July 19, 2011

RE: STARK COUNTY  
CITY OF LOUISVILLE  
LOUISVILLE HIGH SCHOOL  
ADDITIONS & RENOVATIONS  
CONSTRUCTION STORM WATER

Figure 1 – The Dandy Bags on the storm drains need to be cleaned and reinstalled.

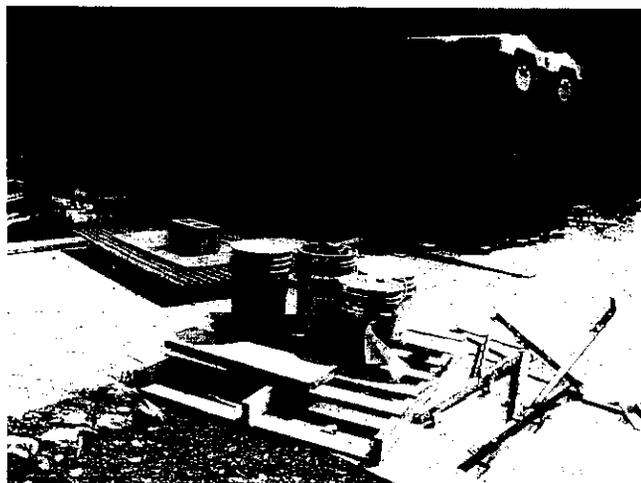
1. Sediment has collected on the Dandy Bags that are covering the storm drains (Figure 1). Please clean and reinstall these Dandy Bags.
2. Construction debris and uncovered paint containers are present in the construction area (Figure 2). Please dispose of construction debris in an appropriately-marked dumpster to prevent trash from leaving the site. In addition, please cover all containers that contain potentially harmful materials, such as paint, to prevent these pollutants from being spilled onto the ground.
